H12260

## DESCRIPTIVE REPORT

*General Locality* Krenitzin Islands

## Revisions and Corrections performed during office processing and certification.

**Figure 2 Profile of 2A01-TIE02**

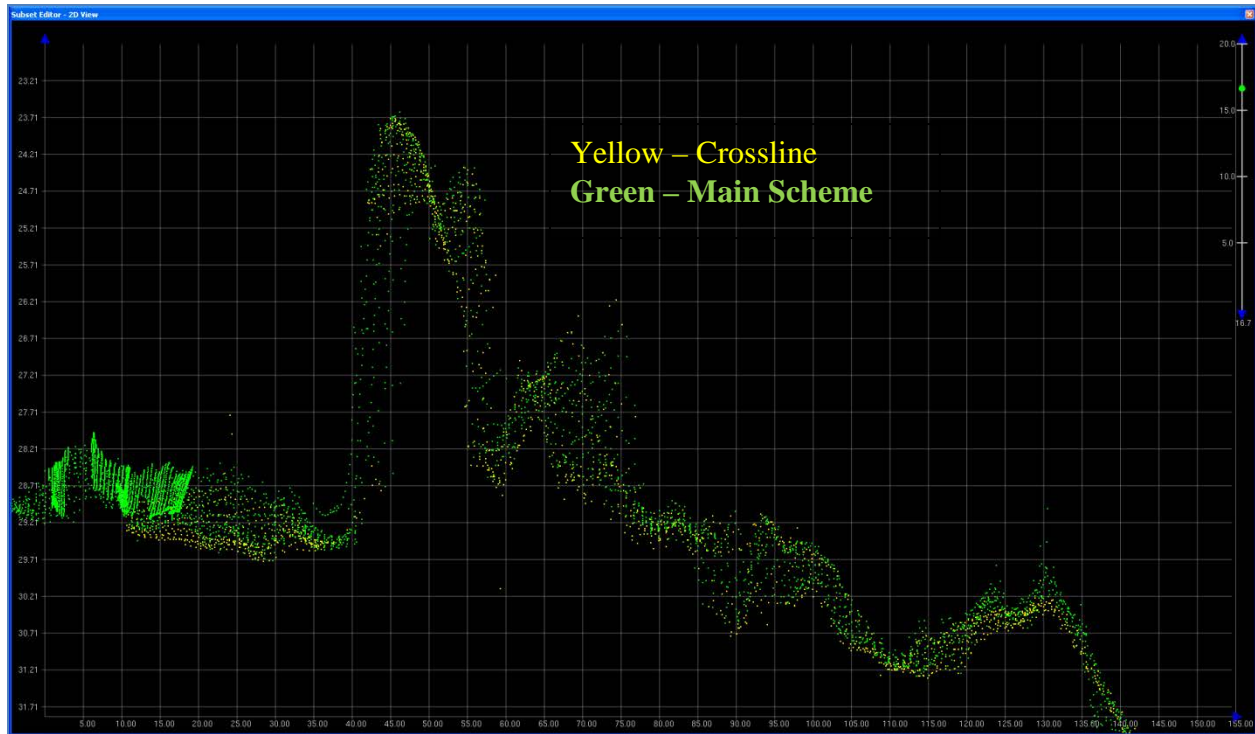
The majority of QC Reports fall well within the required accuracy specifications. The one exception is several crosslines run by R2 in shallow areas near Ugamak Island. The R2 QC report beams fall below the 95% confidence level due to steep slopes and significant rock ledges. Good conformity was still seen between the main scheme lines and crosslines. Main scheme lines are shown in green and crosslines in yellow. Quality Control Results are located in Separate IV.<sup>2</sup>

<sup>2</sup> The effect of slope and rocky seafloor on confidence level are as expected. Resulting depths were used for updating the chart, but enclosed inside rocky area features as an added precaution.

**Figure 6 Bathymetry overlaid on Chart 16531**

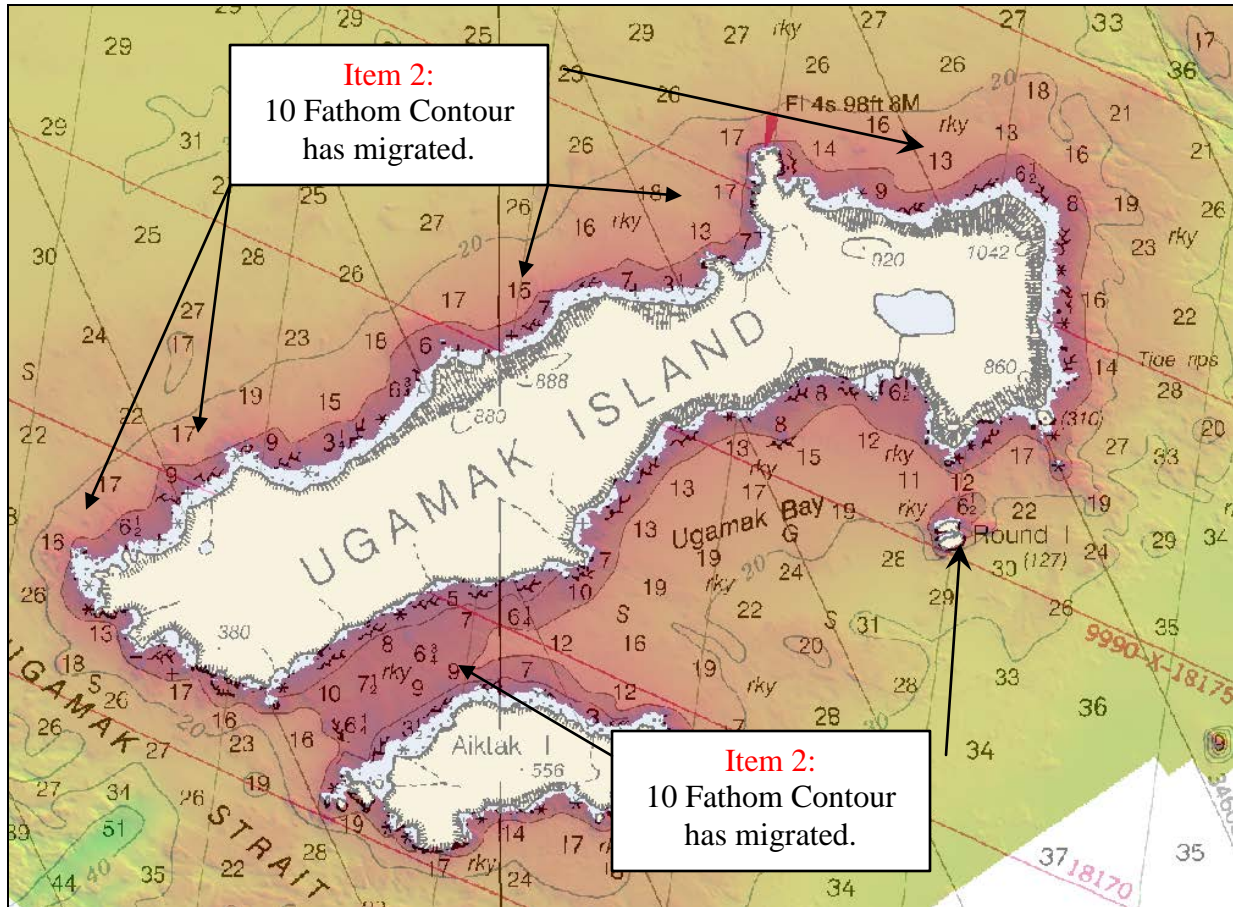
4. Hydrographic survey H12260 revealed a depth of 18.68 fathoms in the vicinity of a 27 fathom sounding on chart 16531 located at 54°12'22"N 164°54'04"W. This area was surveyed with 100% multibeam coverage. The shoaling is centered in the area depicted below.<sup>8</sup>

5. Hydrographic survey H12260 revealed a depth of 16.96 fathoms in the vicinity of a 26 fathom sounding on chart 16531 located at 54°13'43"N, 164°49'24"W. This area was surveyed with 100% multibeam coverage. The shoaling is centered in the area depicted below.<sup>9</sup>

6. Hydrographic survey H12260 revealed a depth of 12.55 fathoms in the vicinity of a 19 fathom sounding on chart 16531 located at 54°12' 14"N, 164°45'30"W. This area was surveyed with 100% multibeam coverage. The shoaling is centered in the area depicted below.<sup>10</sup>

<sup>8</sup> See Figure 8. A 19 fm depth was selected for charting.

<sup>9</sup> See Figure 8. A 17 fm depth was selected for charting.

<sup>10</sup> See Figure 8. A 12 fm depth was selected for charting.

**Figure 9 Bathymetry overlaid on Chart 16531**

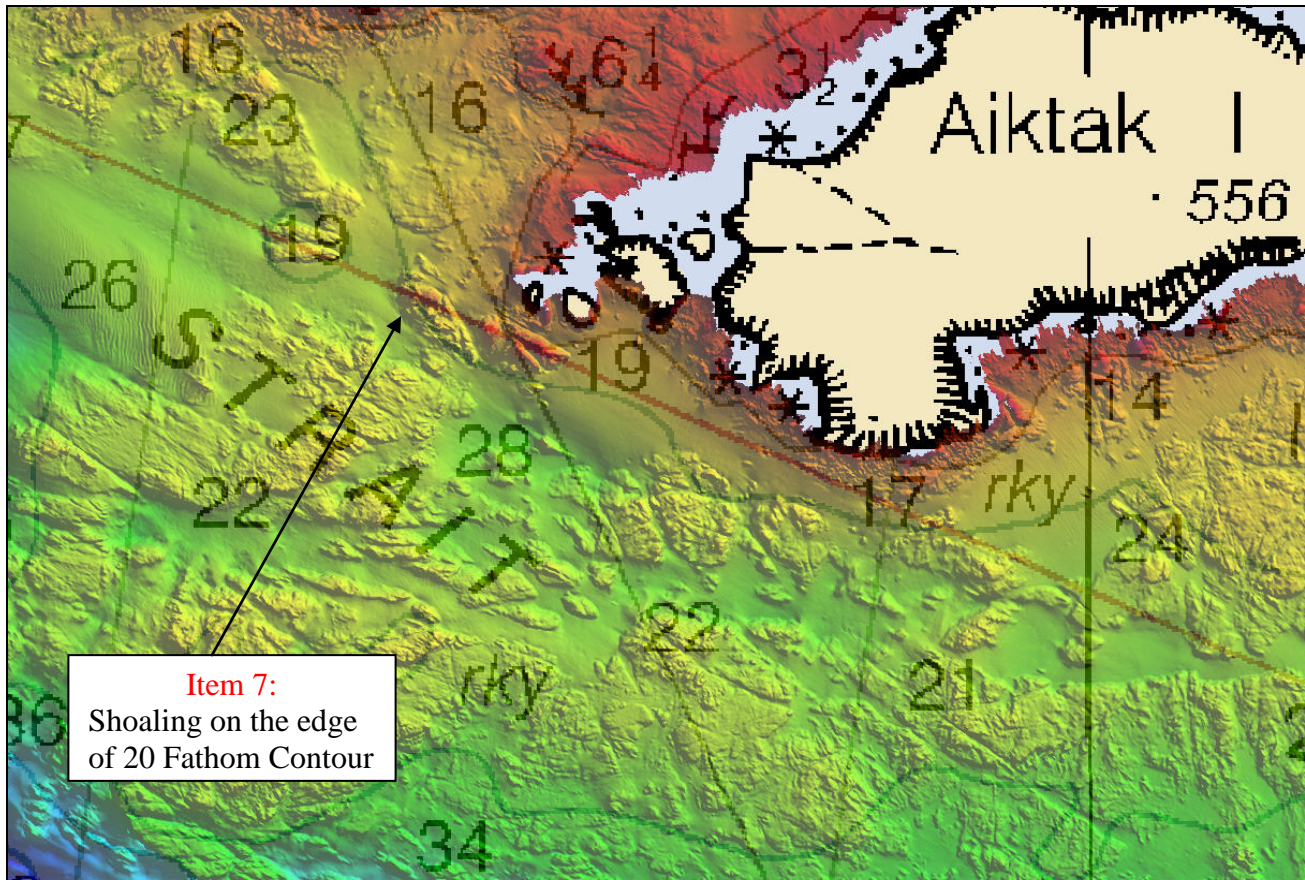
7. Hydrographic survey H12260 revealed a depth of 10.26 fathoms on the 20 fathom contour boundary on chart 16531 located at 54°10'55"N, 164°51'32"W. This area was surveyed with 100% multibeam coverage. The shoaling is centered in the area depicted below.<sup>11</sup>

<sup>11</sup> See Figure 9. A 13 fm depth nearby was selected for charting, and new contours included in the survey scale chart update product.

DTON: A 9.6 fathom sounding acquired near a 32 fathom sounding (Chart 16531)

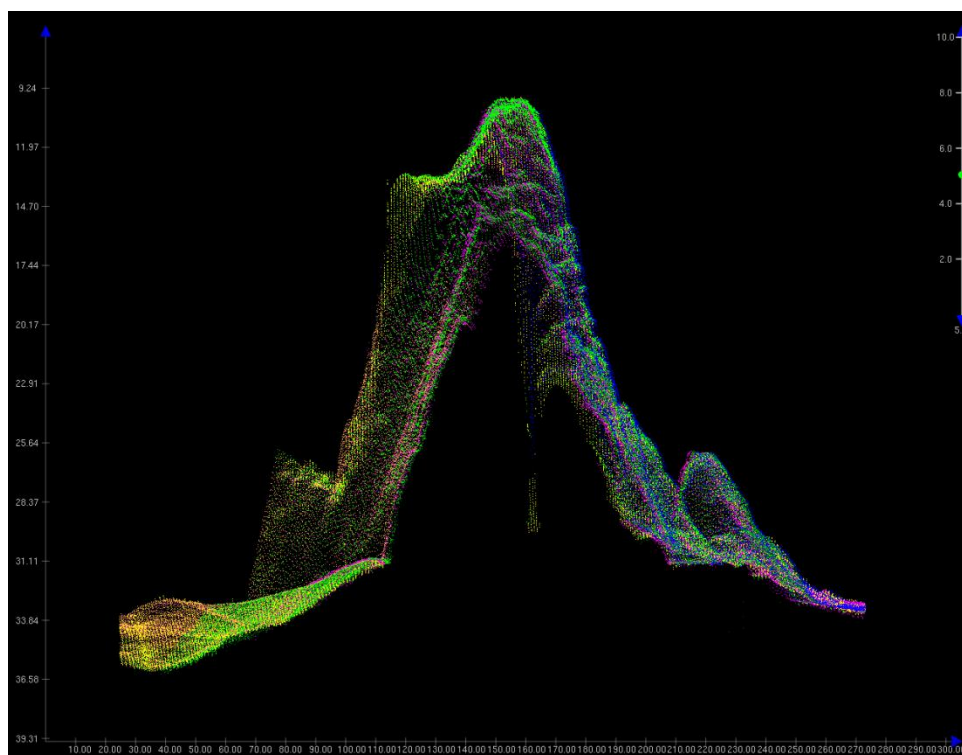
Feature	Depth	Latitude	Longitude	Time (UTC)
1. Sounding	9.6 fathoms	54-11-10.16N	164-44-36.23W	2010-06-25 13:29:59.983

DTON #1 was applied to the chart by MCD as a 9 fm shoal.

After final tides were applied and Surfaces recomputed, the shoal feature was compiled to the chart update product as a 10 fm 4 ft submerged rock.

**Figure 1: Feature 1**

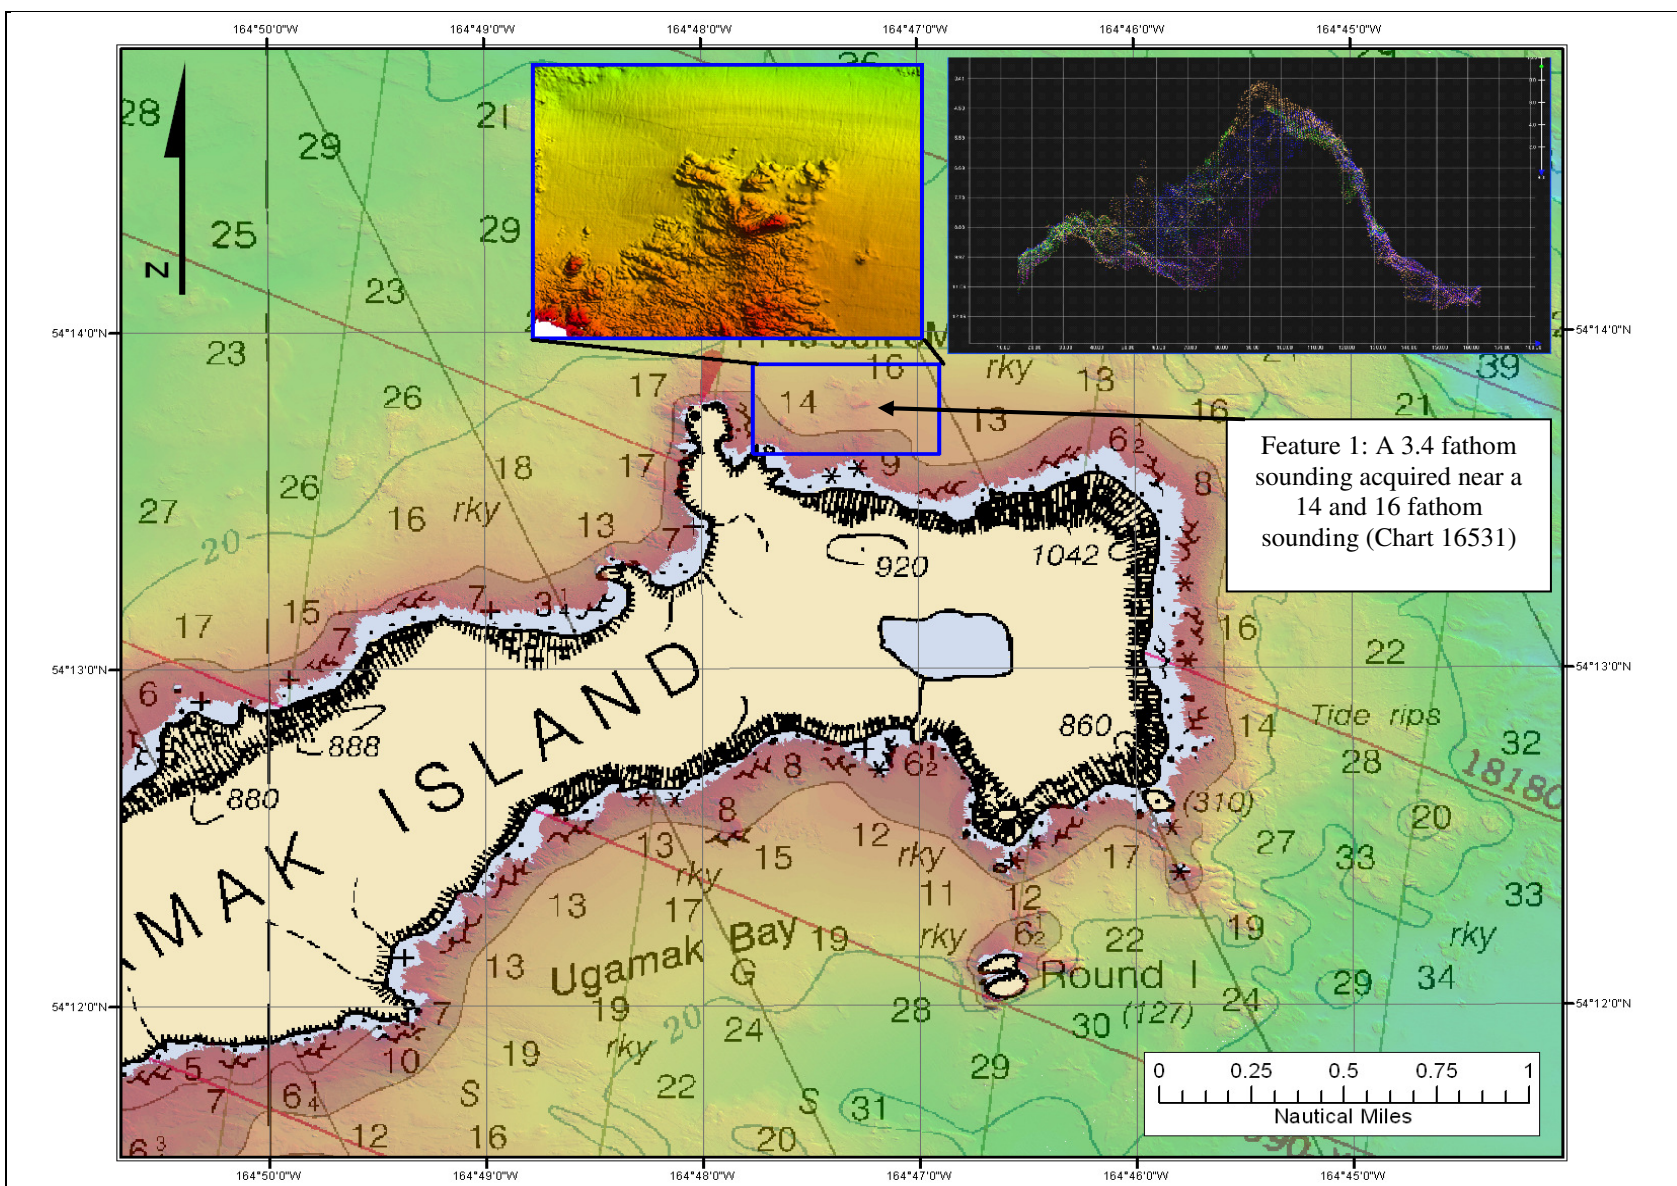
Feature	Depth	Latitude	Longitude	Time (UTC)
1. Rock	3.4 fathoms	54-13-46.85N	164-47-15.35W	2010-06-20 02:20:58.458
2. Rock	1.9 fathoms	54-12-06.64N	164-46-19.79W	2010-06-10 21:33:41.432
3. Rock	1.6 fathoms	54-11-39.62N	164-50-40.56W	2010-06-10 22:57:07.831
4. Rock	3.3 fathoms	54-11-15.78N	164-51-15.60W	2010-07-05 21:08:04.393

DTON #1 was applied to the chart by MCD as a 3-1/4 fm submerged rock;  
 It was compiled to the chart update product as a 3 fm 2 ft submerged rock.  
 DTON #2 was applied to the chart by MCD as a 1-3/4 fm submerged rock;  
 It was compiled to the chart update product as a 1 fm 5 ft submerged rock.  
 DTON #3 was applied to the chart by MCD as a 1-1/2 fm submerged rock;  
 It was compiled to the chart update product as a 1 fm 3 ft submerged rock.  
 DTON #4 was applied to the chart by MCD as a 3-1/4 fm submerged rock;  
 It was compiled to the chart update product as a 3 fm 2 ft submerged rock.

**1.1) Profile/Beam - 1477/465 from sheet\_a03 / 3-d2 / 2010-184 / 3a03-sh208****DANGER TO NAVIGATION****Survey Summary**

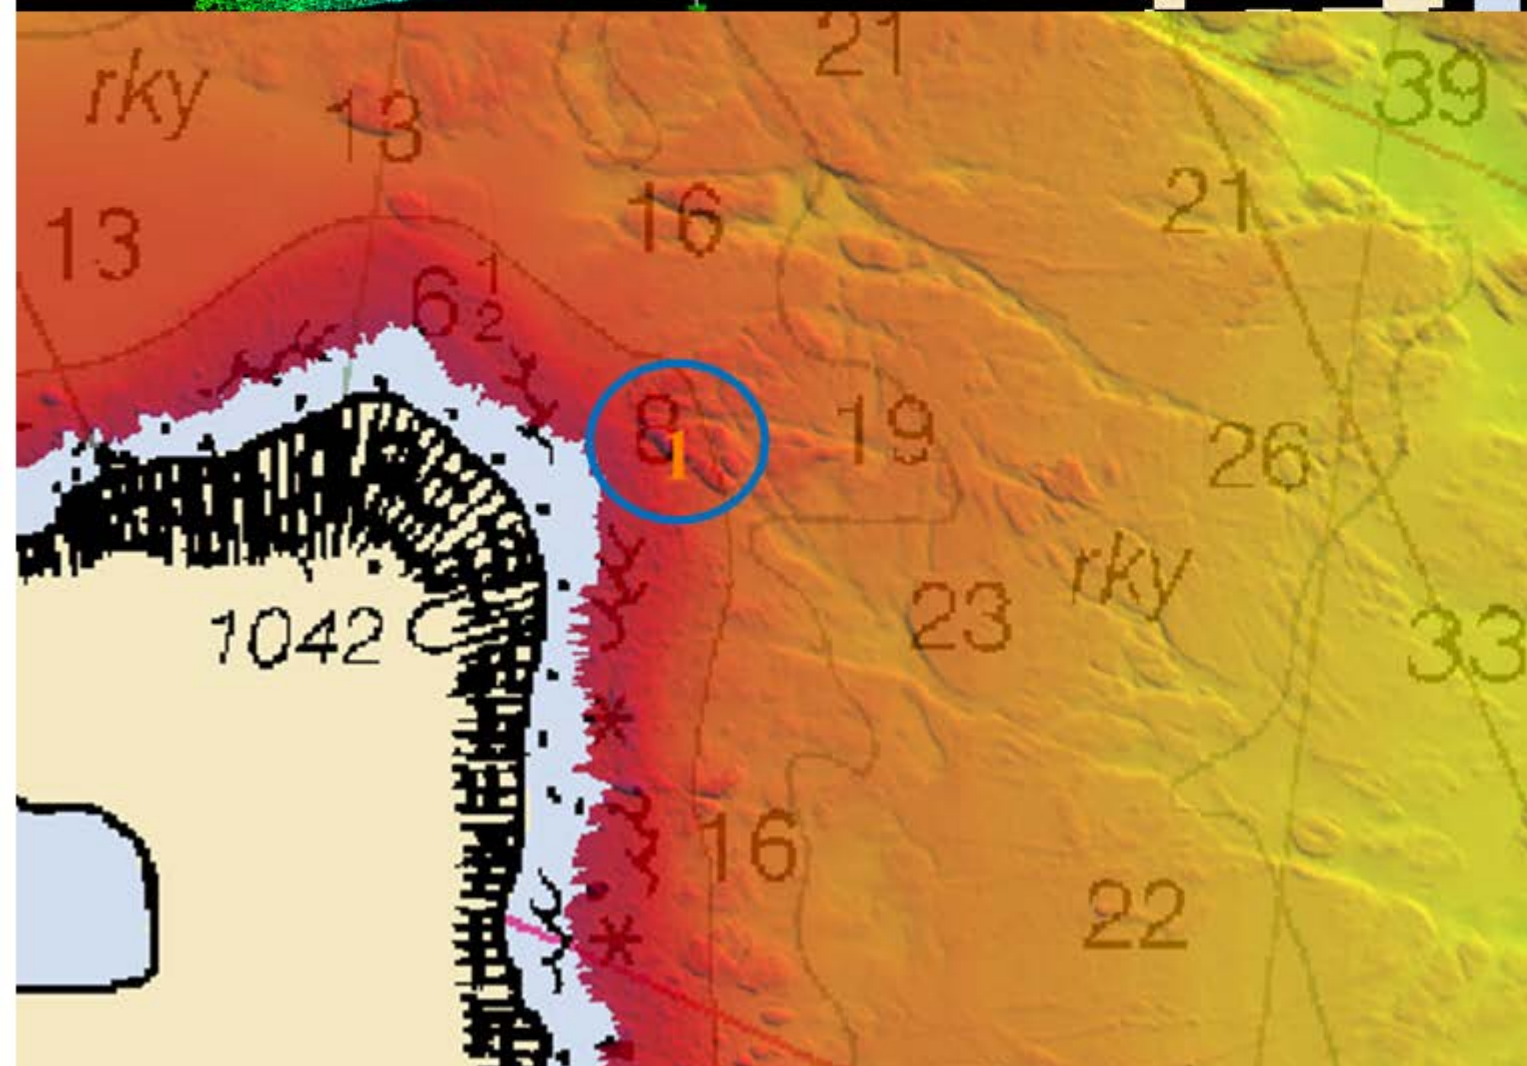
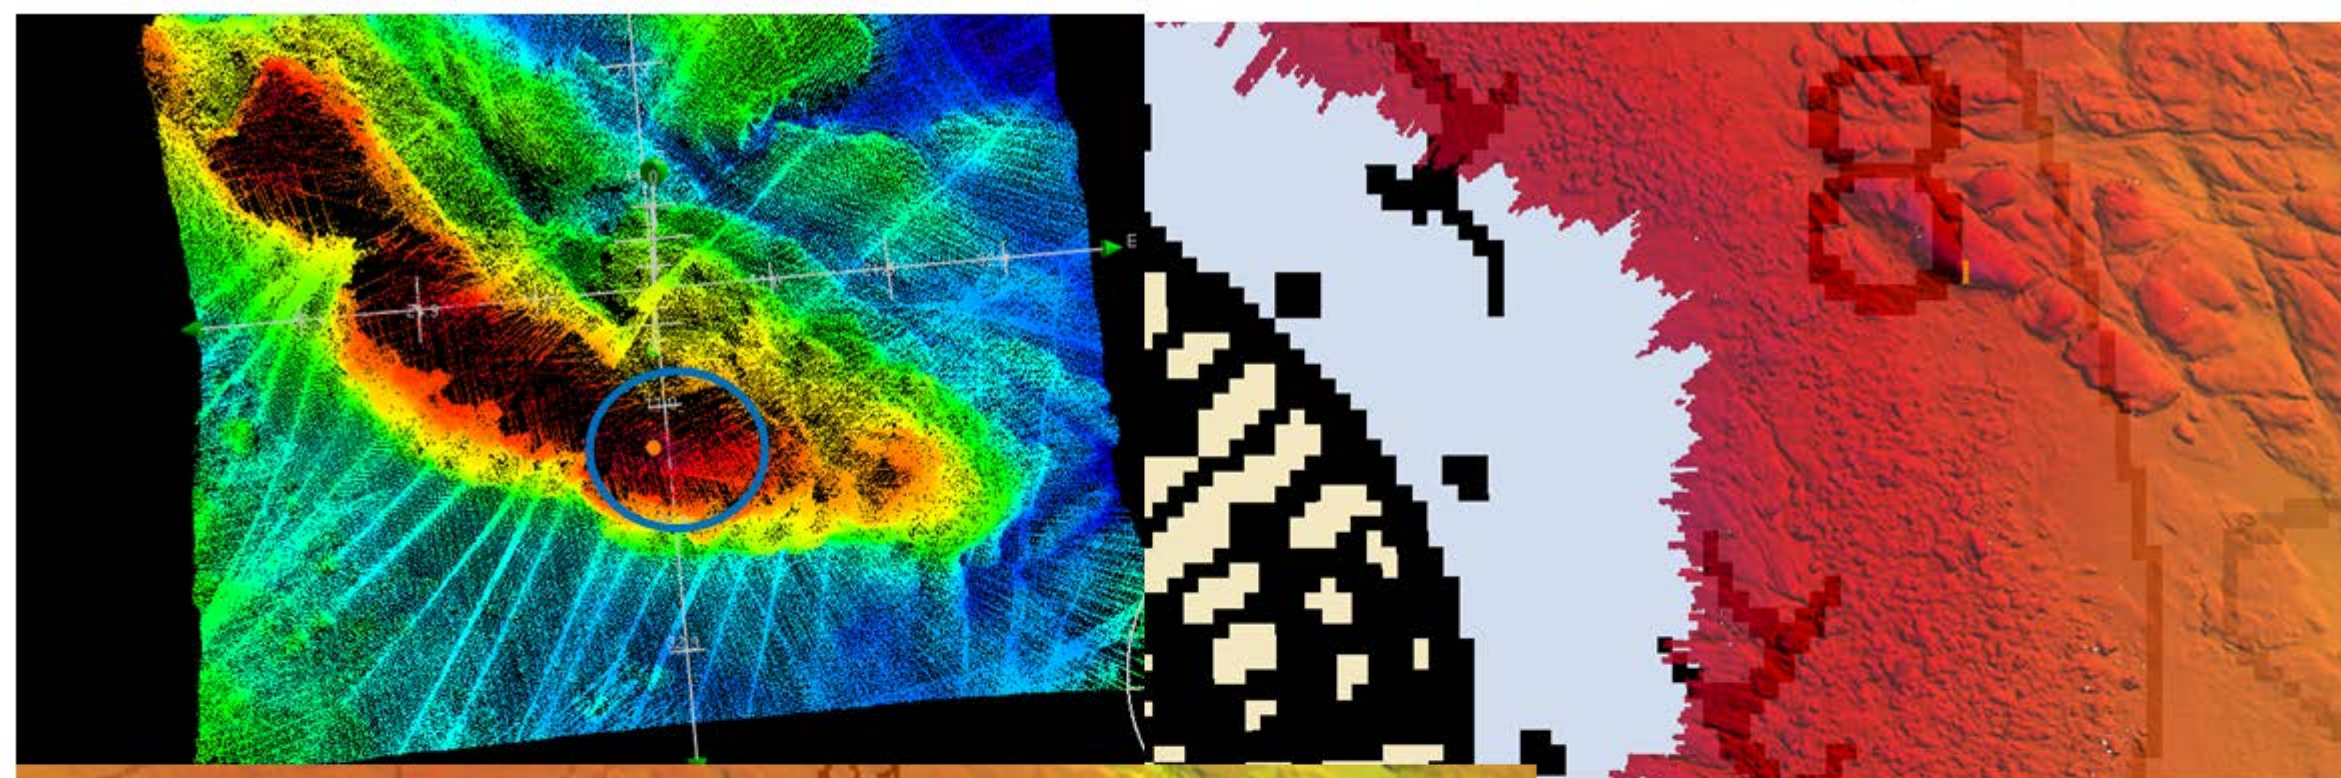
315m ENE off NE Ugamak Island, 1fm sdg.

submit as DTON

DTON #1.1 was applied to the chart by MCD as a 1 fm shoal

It was compiled to the chart update product as a 1 fm submerged rock.
